HOWARD COUNTY HISTORIC PRESERVATION COMMISSION
ELlicott City Historic District ■ LAWYERS HILL Historic District
3430 Court House Drive ■ Ellicott City, Maryland 21043

2017 Minutes

February Minutes

Thursday, February 2, 2017; 7:00 p.m.

Figure 20 - Proposed dimensions

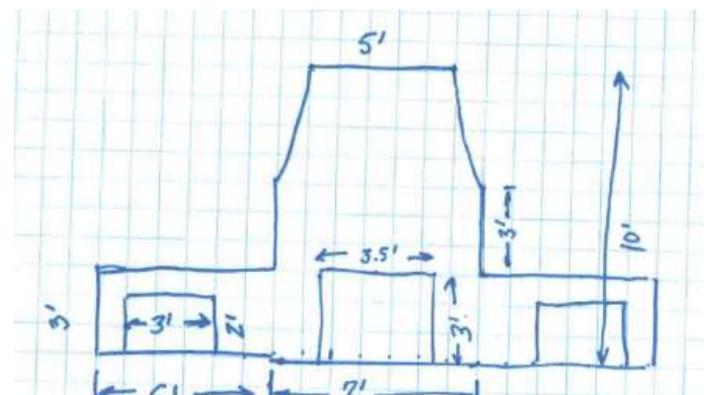
Staff Comments: The dimensions of the fireplace appear proportionate. The materials comply with Chapter 9.D of the Guidelines (page 70) and will match other stonework in the direct vicinity, “construct new site features using materials compatible with the setting and with nearby historic structures, particularly for features visible from a public way.”

Figure 26 - Proposed pedestrian bridge

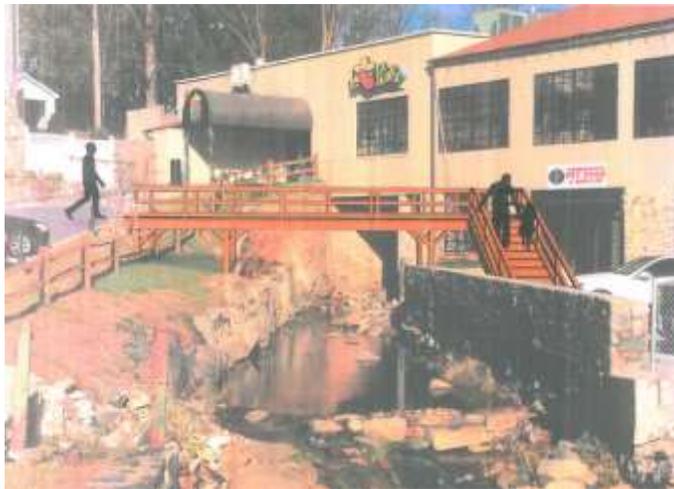
Staff Comments: Prior to the July 30 flood there was a pedestrian footbridge about 40 feet south of the proposed location, over the same channel. Chapter 9.A recommends, “maintain and reinforce natural landscape elements, such as rock outcroppings, water courses and tree lines. Make views of natural elements, especially the Patapsco River and its tributaries available to the public where possible. Provide walkways, sitting areas and casual stopping spots in parks, plazas and other areas open to the public.” The proposed footbridge would be a walkway taking advantage of a landscape element as recommended by the Guidelines, however access to and from is on private property. Staff notes this bridge is crossing a river and is located within part of the floodplain and recommends all proper approval for permitting and review be done by the County and MDE before constructing.

Figure 38 - Existing stone foundation

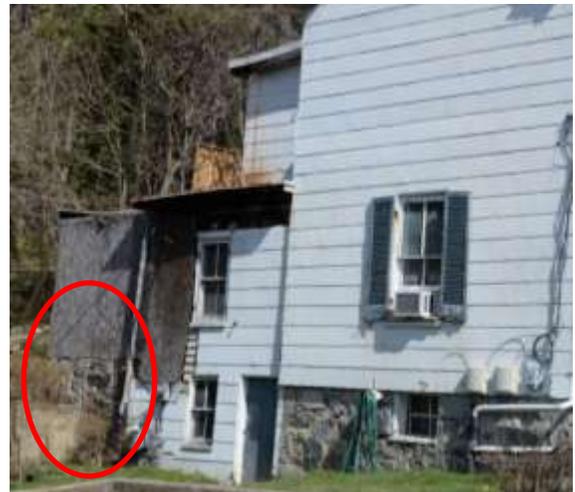
There is a stone foundation on the existing rear porch. Staff inquired about this item at the December meeting, but did not receive any clarification. Staff recommends this stone be reused for the foundation for the new porch, which complies with Chapter 7.B recommendations, “use materials compatible with the existing building for the exposed masonry foundation or piers of a new porch. Poured concrete or concrete block foundations or piers should be given a surface treatment compatible with historic building materials.”

The proposed stain and painting complies with Chapter 7.B recommendations, “on historic buildings construct porches of painted wood rather than poured concrete, metal or unpainted wood. Use stained or unpainted wood only for less visible features of a new porch, such as the decking and steps treads...on the rear of building in a location not facing or highly visible from a public way.” Staining would be appropriate for this porch as it will be visible, but the decking should not be highly visible over other features of the rear porch.

Figure 4 - Approved plans for rebuilding front porch

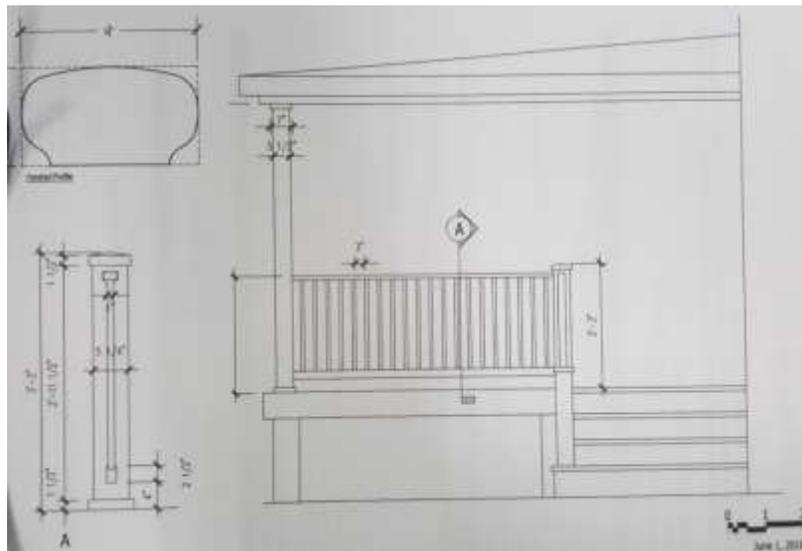
The original design for the porch included round columns, but after Staff indicated that was not an historically appropriate design, the Applicant revised the porch columns and railings to be square, as shown in the approved design in Figure 4. The porch railings and columns that were constructed do not match this design. The approved end railing has an open design and the columns have a square base and capital.

The current proposal plans to connect these two previously approved items with a side porch. For clarity in this proposal the original porch will be referred to as the front porch, the deck off of the kitchen will be referred to as the rear deck and the proposed connecting porch will be referred to as the side deck.

Figure 13 - East Elevation

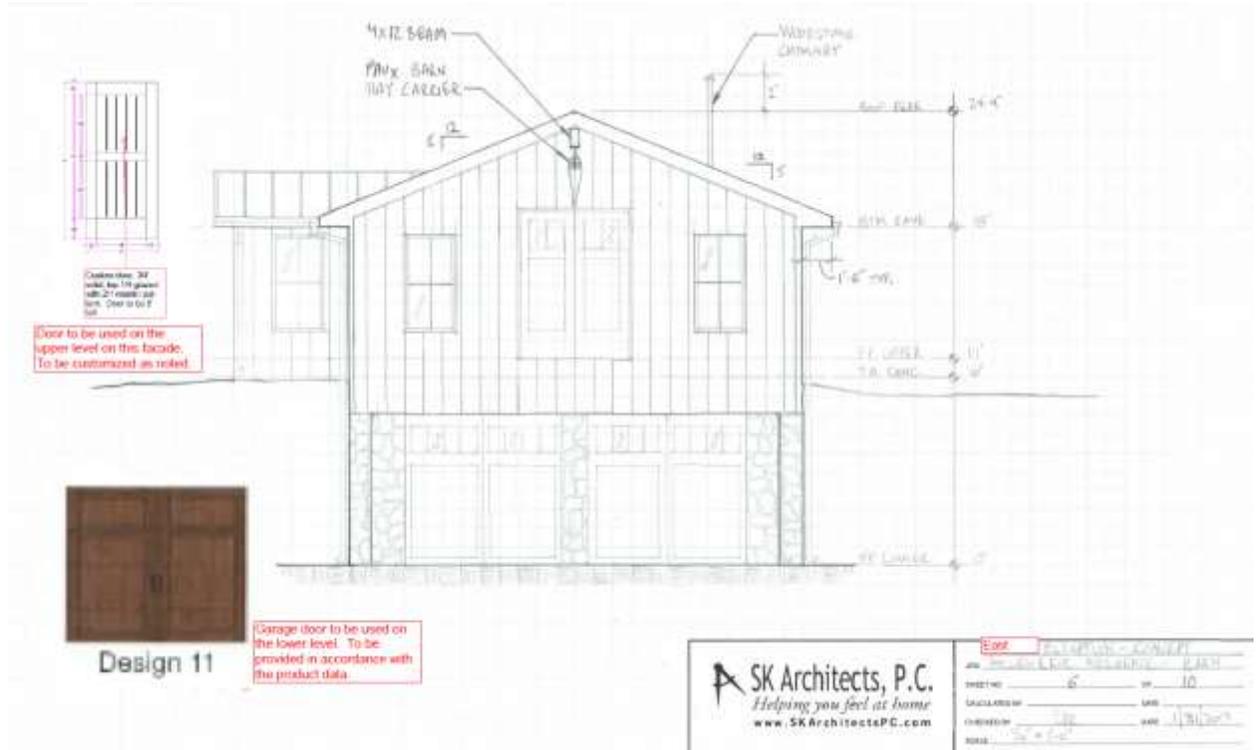
East Elevation (labeled South elevation on submission) - Overhead garage sectional doors on the lower level will be faux carriage house garage doors built out of a composite material that will be painted Sherwin Williams Roycroft Copper Red with black hardware. The upper level barn style doors will be a wood custom built door 2 lite over 1 panel with v-groove detail in the panel. There will be three windows visible from this elevation. This side of the building will also have a 4x12 beam installed to resemble a barn hay carrier. A pulley will be affixed to the beam and will either be weathered steel or painted black. This item will not be functional.

Figure 15 - West Elevation

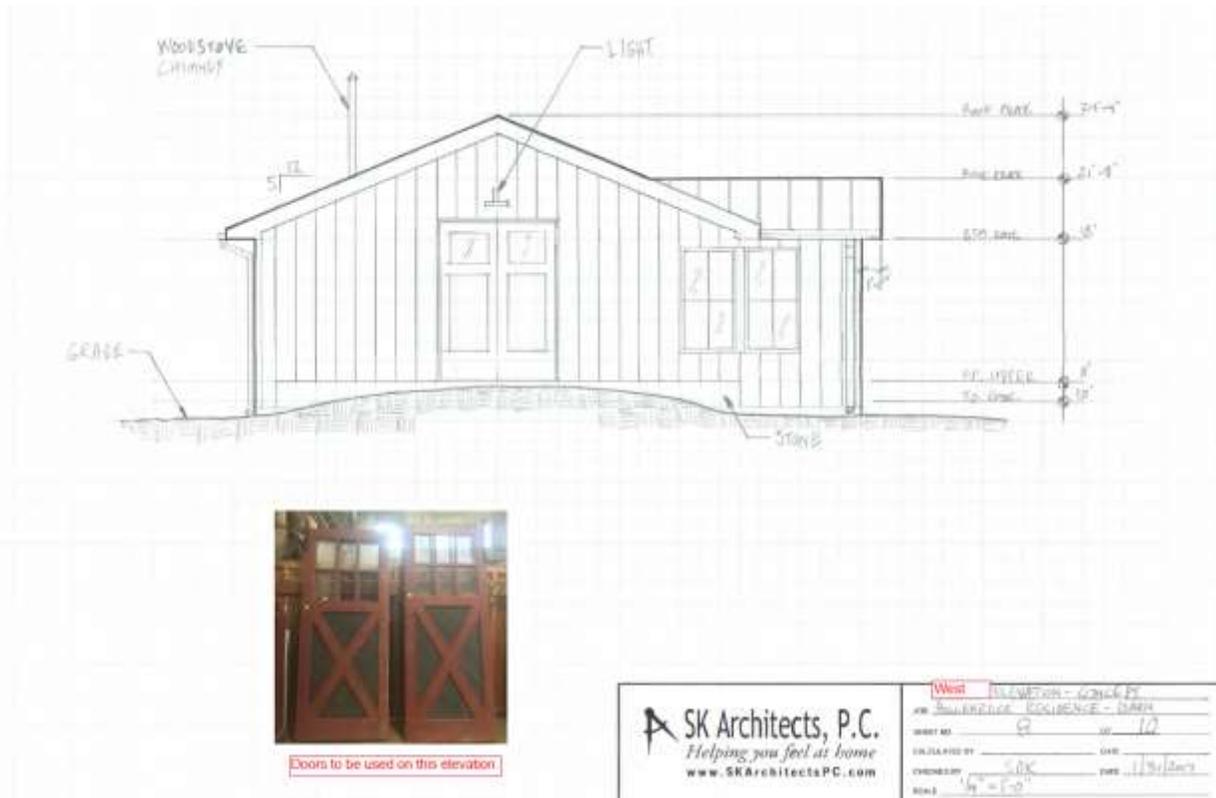
West Elevation (labeled North elevation on submission) – There will be one pair of doors on this elevation, which are salvaged doors with 6 lights over 1 ‘x’ panel. The doors will be painted Sherwin Williams Roycroft Copper Red with black hardware. There are two windows visible on this elevation. There will be one light on this side of the building, over the paired door.

Figure 20 - Proposed site plan showing demolition of historic house and construction of new building

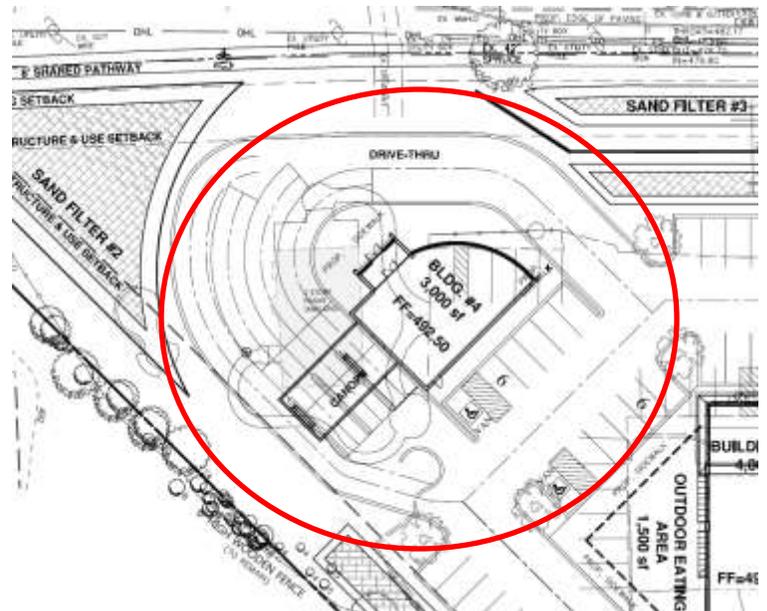
The existing historic house directly fronts Clarksville Pike and complies with the Clarksville Pike Guidelines, which recommend, "buildings should front onto Clarksville Pike, buildings should be set close to the street and primary building entrances should be oriented to the street." The existing building complies with these Guidelines, while the proposed new structure at this location does not, as shown in Figure 20.

Figure 27 - Proposed capstone for retaining wall

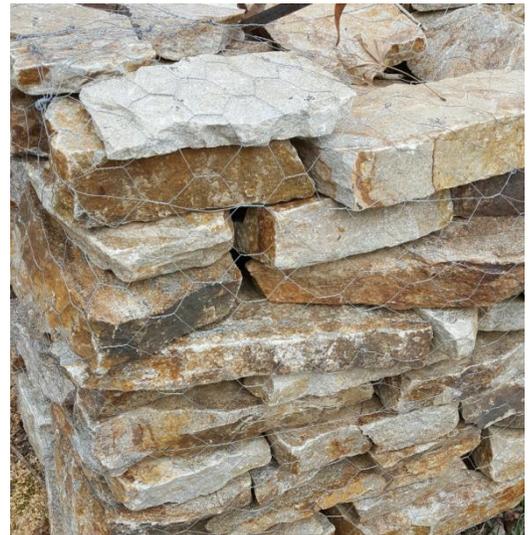
- 6) The Applicant has built a walkway and patio, and begun construction of the retaining wall and built in fireplace/chimney on the right side of the house. Wrought iron handrails have been added to previously existing steps, as required by the homeowners insurance. The retaining wall is being constructed out of concrete block and will be faced with stone to match the historic building.
 - a. The capstones for the retaining wall for the walkways and patio will be Maryland Supreme irregular flagstone.
 - b. Install capstone on historic front wall to match the others that will be used on the property.

Figure 42 - Brick side walkway

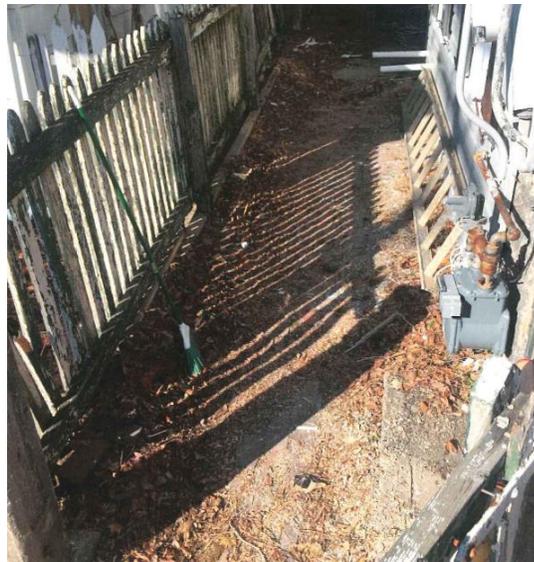
- 4) There is existing brick paving on the south west side of the house. The Applicant proposes to remove the brick, pour a concrete slab and install new brick pavers in the side walkway.

Figure 9 - Proposed location of deck

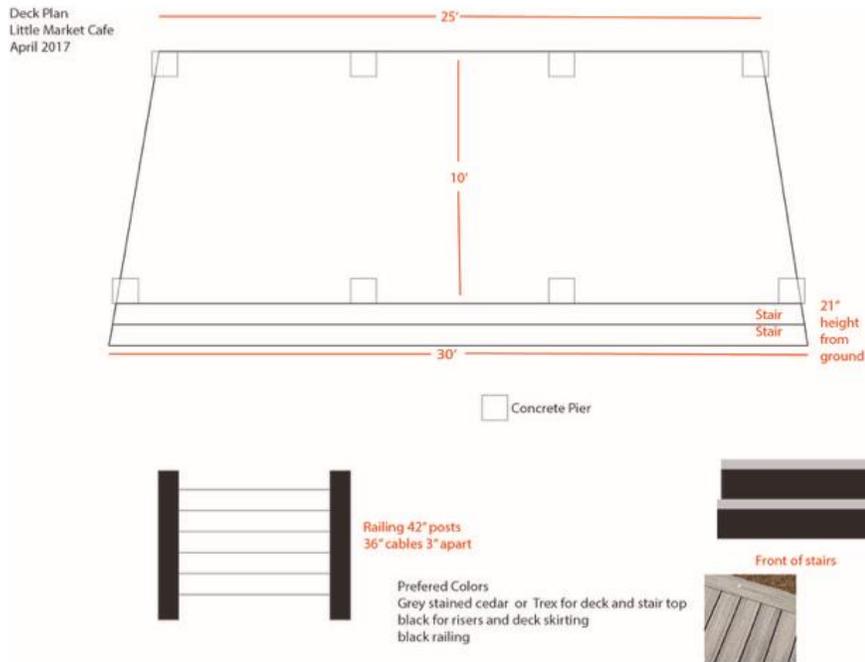
along Hamilton Street/Parking Lot D. A few of the details on the deck have changed from the application that was submitted. The deck will be constructed out of cedar wood stained Cape Cod Gray and will be shaped like a trapezoid and sit on concrete piers 21 inches from the ground. The deck will be 25 feet wide at the back along the parking lot and flare out to 30 feet wide in the courtyard. Excluding the steps, the deck platform will be 10 feet deep. The deck will have open stairs the entire width to create a more natural transition to the yard. The Applicant proposes to use black metal railings with silver horizontal safety rails. The railings will have 42-inch high posts with 36-inch wide cables spaced 3 inches apart. The existing mulched area will be graded as needed in order to construct the deck. This new deck plan can be seen in Figure 10.

Figure 3 - Approved alterations to east side of building HPC-16-101

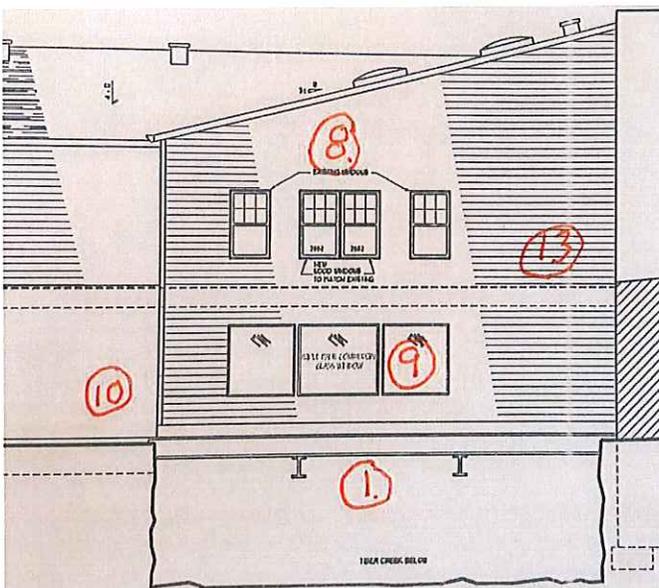
The Applicant seeks approval to replace the wood siding on the east side of the building that spans the Tiber River with Boral TruExterior Siding from the Craftsman Collection in Cove/Dutch Lap. The product has the same profile as the existing wood siding, as shown by a sample submitted. The Boral website states that the Boral siding “installs with standard woodwork tools and methods, accepts paint of any color, resists rot and termite attacks, maintains a high level of dimensional stability and does not crack or split from moisture.” The Boral siding will be painted tan (McCormick Paints ‘Courtyard’ 0344) which was the previously approved color from case 16-101. Figures 3 and 4 below show alterations that were approved in HPC-16-101.

Figure 20 - Proposed sign

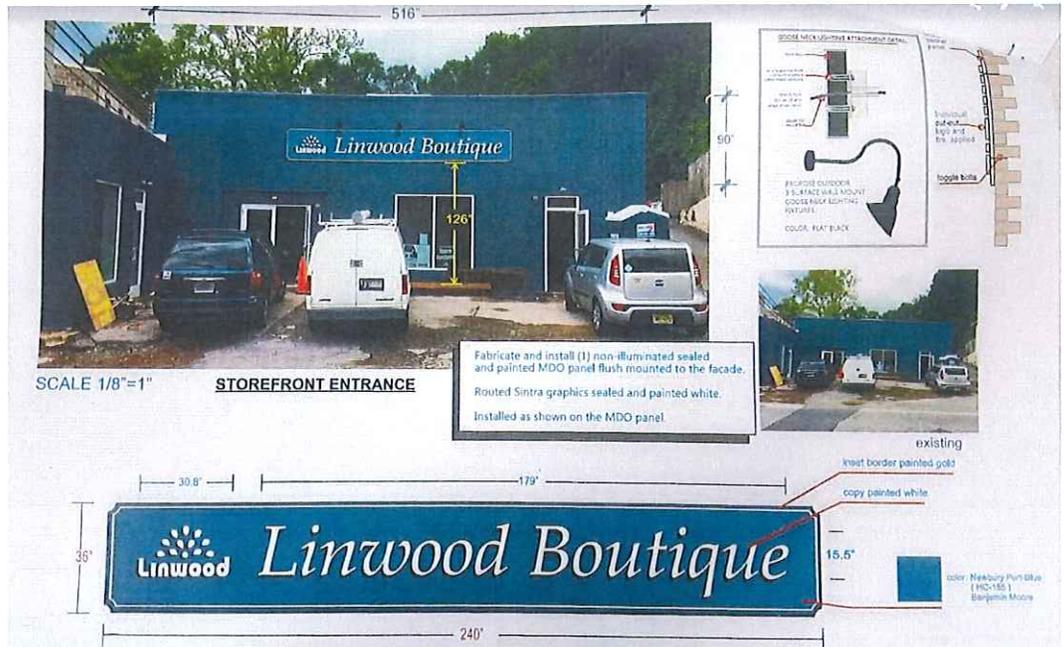
Background & Scope of Work: This building is located in the Ellicott City Historic District. The exact date of construction is unknown, but this building shows up on the 1959 Sanborn maps. The Applicant seeks approval to install a flat mounted sign on the front of the building. The proposed sign will be 3 feet high by 20 feet wide, for a total of 60 square feet. The sign will be one flat MDO panel with sign foam routed lettering that is attached to the panel. Three black gooseneck lights will be installed above the sign. The sign rendering shows that there will be an inset border painted gold, the letters will be painted white and the background of the sign will be Benjamin Moore Newbury Port Blue, the same color as the building. The letters will be 15.5” inches tall. The sign will read on one line, “Linwood Boutique” with the Linwood school logo and the word ‘Linwood’ prior to the store name.

Figure 21 - Temporary banner on facade

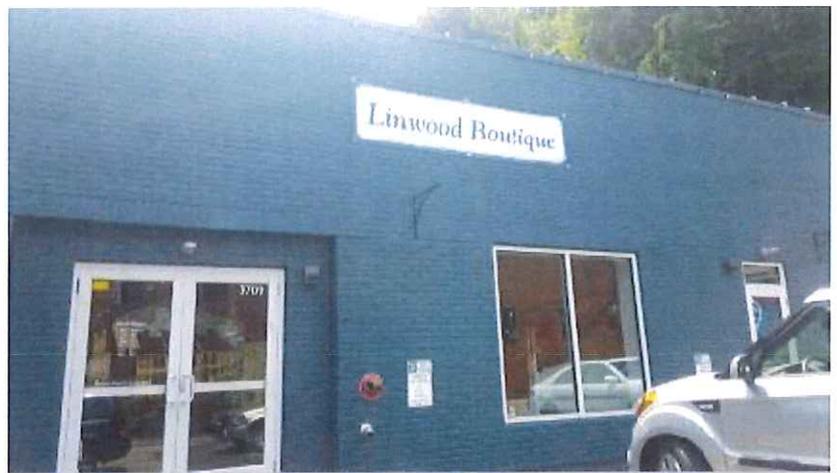
Alternatively, the size of the temporary banner that has been installed on the front of the building is more appropriate in size and scale and better complies with the Guidelines. The banner appears to be similar in size to the width of the windows, which utilizes an existing proportion from the building, making the size appropriate. The banner also contains a white background, which better contrasts with the building than the proposed blue sign.

Figure 28 - Proposed fence styles

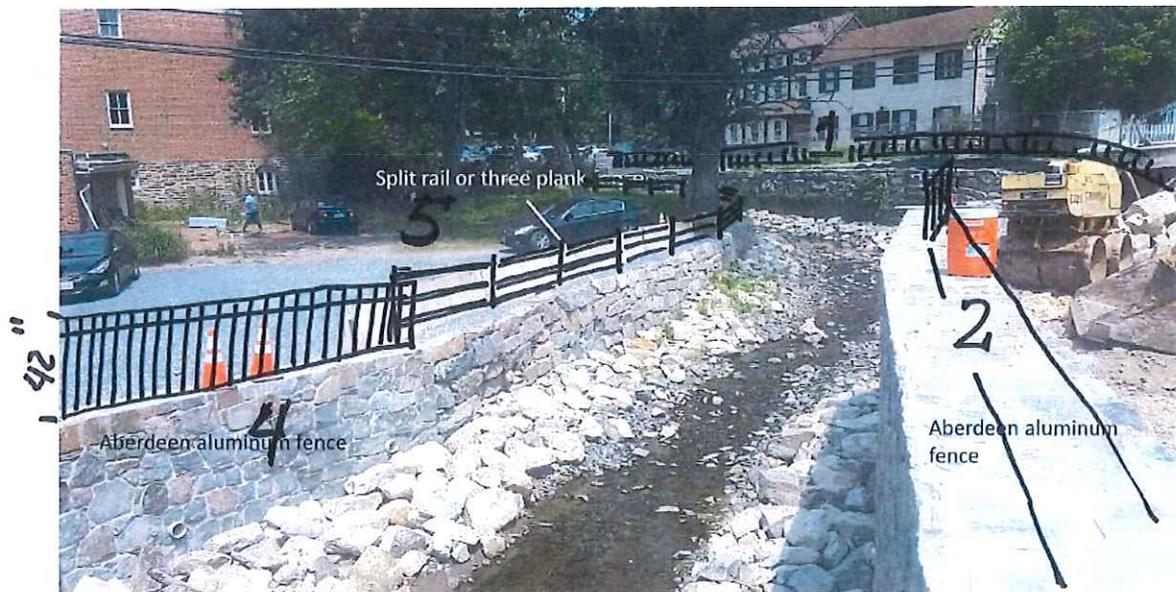
The Applicant has proposed the two fence types in order to distinguish between private property and County property and to lessen the potential severity of the look of a large amount of black metal fencing. The Applicant is open to any fencing suggestions by the Commission and can change the wood fence to metal if desired.

Figure 25 - Front elevation showing proposed alterations

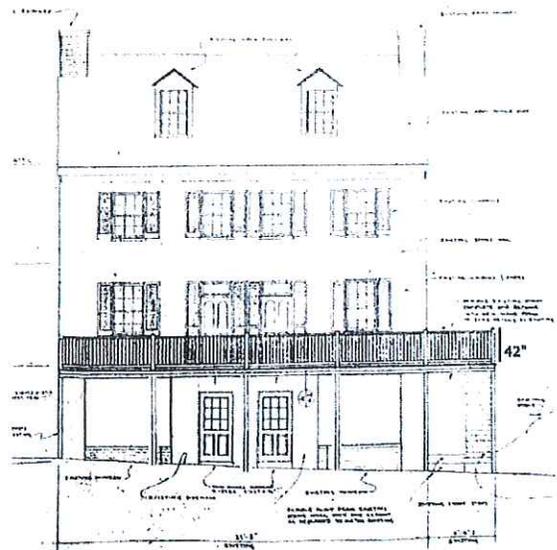
feet of depth to the porch may not seem like a large change, it will affect the building in several ways. It will be changing the distinctive features of the building and it will be creating a false sense of historical development. This porch was used as a passageway to the doors and was not used for dining. Regarding the changes to the distinctive features of the building, the proposed porch alteration will require a 6-inch increase in the height of the existing railing. The drawings provided in the application, shown in Figure 25, show that the railing would end at the lintel of the second-floor windows. If the drawing is accurate, this would be a perspective that would only be visible from a building across the street on the second floor. When the building is currently viewed from across the street, as shown in Figure 24, the existing railing appears to end just above the window lintel. If this railing is raised 6 inches in height, to 42 inches, and moved two feet further out, it will be blocking substantially more of the windows and doors. Additionally, the view of the second and third floors of the building from the sidewalk below will be blocked by the porch protruding an additional two feet in depth.

Figure 6 - Proposed rear elevation

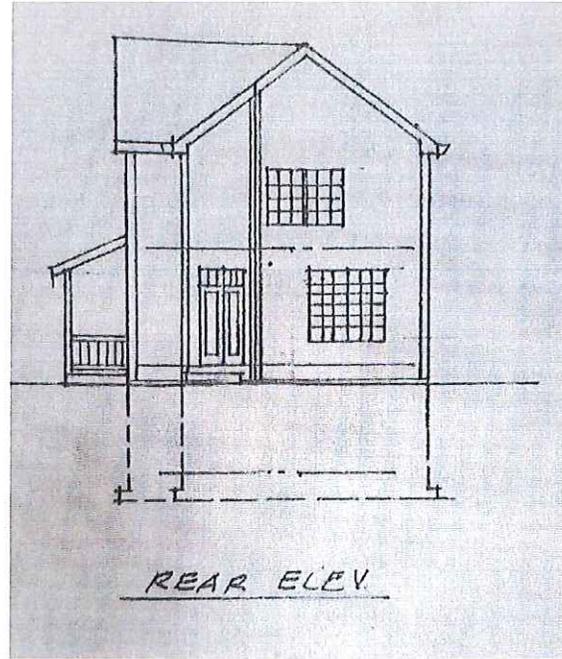
Staff Comments: The proposed 15-foot front setback will make this structure consistent with the siting of the historic structures along Old Columbia Pike. The historic structures along Old Columbia Pike are all located within a similar proximity to the street. Regarding new construction of principle structures, Chapter 8 of the Guidelines states, “compatibility with neighboring buildings in terms of form, proportion, scale and siting is the highest priority. If these are resolved, details such as colors, material or window design can be more easily dealt with” and “evaluate the appropriate front setback based on the pattern along the public street adjoining the property. Where existing buildings maintain a uniform setback, locate new building in accordance with the established setback.” Overall Staff finds the proposed design is compatible with the neighboring historic structures. The house will be narrower in width that the neighboring granite structures, which is common in Ellicott City. The new structure will be compatible in proportion, as it will not be larger than existing buildings. The new structure also appears to be similar in width the previously existing historic brick structure that once existed on the lot.
